L-PI-12-030  
10 CFR 72.56

Prairie Island Independent Spent Fuel Storage Installation  
Docket No. 72-10  
Materials License No. SNM-2506

License Amendment Request (LAR) to Revise the Thermal Conductance Requirement  
for Neutron Absorbers and Aluminum Plates in the TN-40HT Cask

**License Amendment Request (LAR) to  
Revise the Thermal Conductance Requirement for  
Neutron Absorbers and Aluminum Plates in the TN-40HT Cask**

**FIGURE A3.3-42**  
**COMPONENT TIME-TEMPERATURE HISTORY FOR FIRE ACCIDENT**  
**WITH LOWER POISON PLATE CONDUCTIVITY**

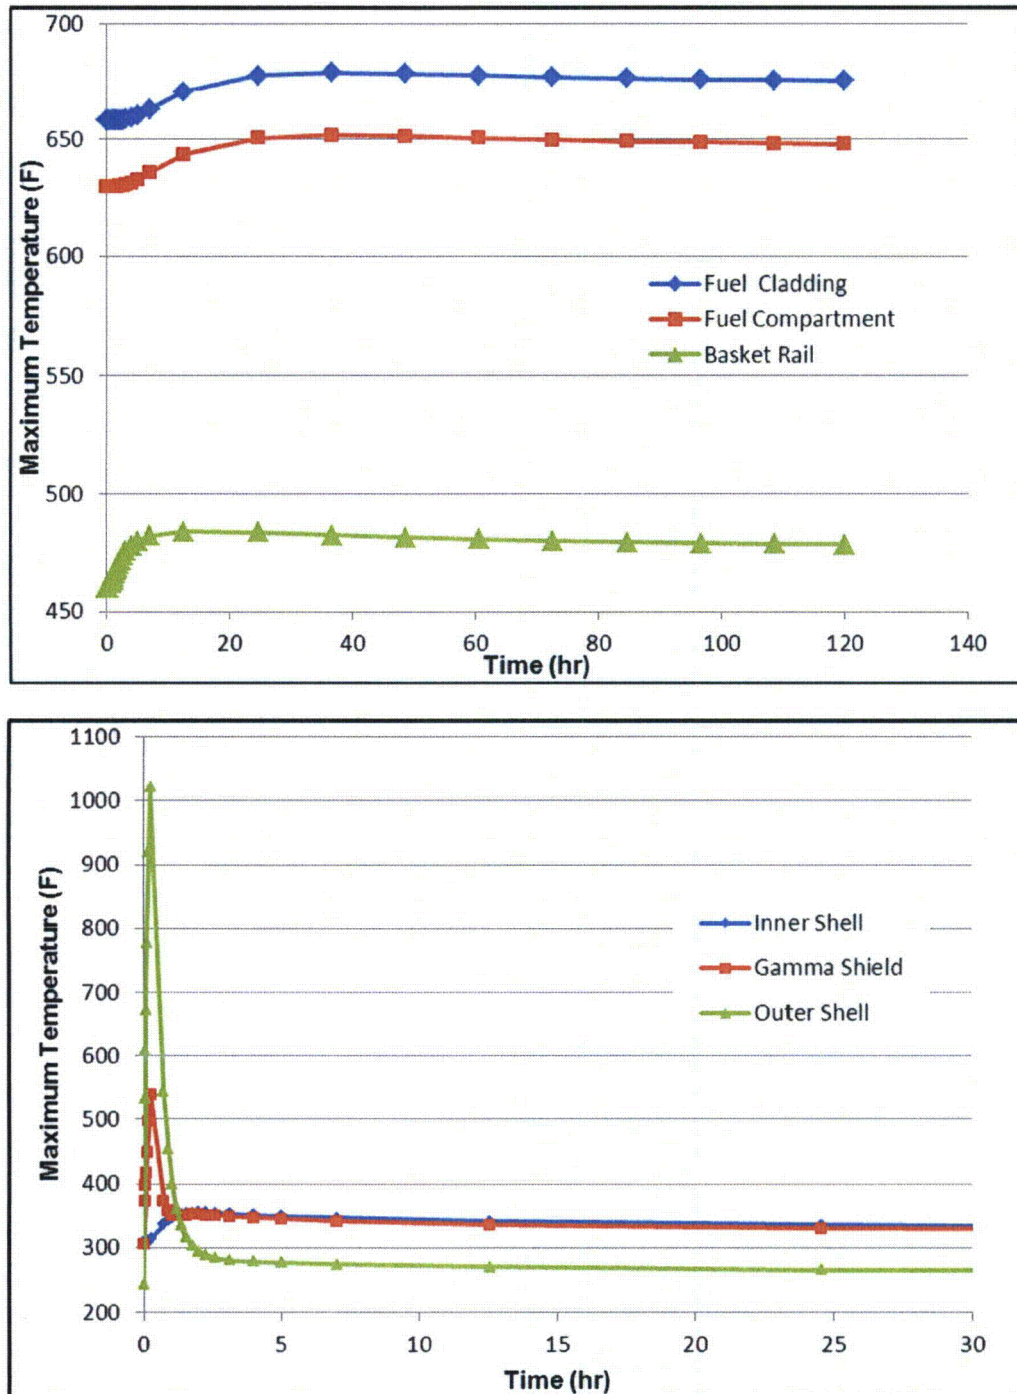
The results of the reanalysis are compared to the results utilizing the design basis models in the previous sections in Table A3.3-35 through Table A3.3-37 for the off-normal storage, hypothetical fire accident, and postulated buried cask accident conditions. The resulting maximum temperature histories of the cask components during fire accident are illustrated in Figure A3.3-42.

As seen in Table A3.3-36 and Figure A3.3-42, the evaluations of the TN-40HT cask with a poison plate conductivity of  $0.68 \text{ Btu/hr-in-}^{\circ}\text{F}$  using the full length cask model for fire accident conditions result in a peak maximum fuel cladding temperature during the transient. As discussed in Section A3.3.2.2.4, the cask cross-section model used as the design basis model does not show a peak temperature until steady state conditions are reached after the fire. The reason for this behavior is that the full length model provides a heat dissipation area which is larger than the active fuel length. Given the long period of time during cool-down and available large heat dissipation area, the maximum fuel cladding temperature decreases slightly as shown in Figure A3.3-42 for the full-length model. The peak maximum temperature and the steady state temperature reported in Table A3.3-36 for the low conductivity model remain bounded by the values resulting from the design basis model.

A comparison of Figure A3.3-14 (page 1 of 2) and Figure A3.3-42 indicates a higher peak maximum temperature for the outer shell when the full length model is used to evaluate the fire accident condition. This higher peak temperature is located at the joint between the outer shell and the top and bottom outer shell ring, which is included in the full length model but not in the cross section model. The outer shell joint region provides a larger area for fire heat intake and thus a higher peak temperature. The high temperature region is localized and concentrated in the joint as shown in Figure A3.3-43 and does not result in a higher volumetric average temperature as shown on Table A3.3-36.
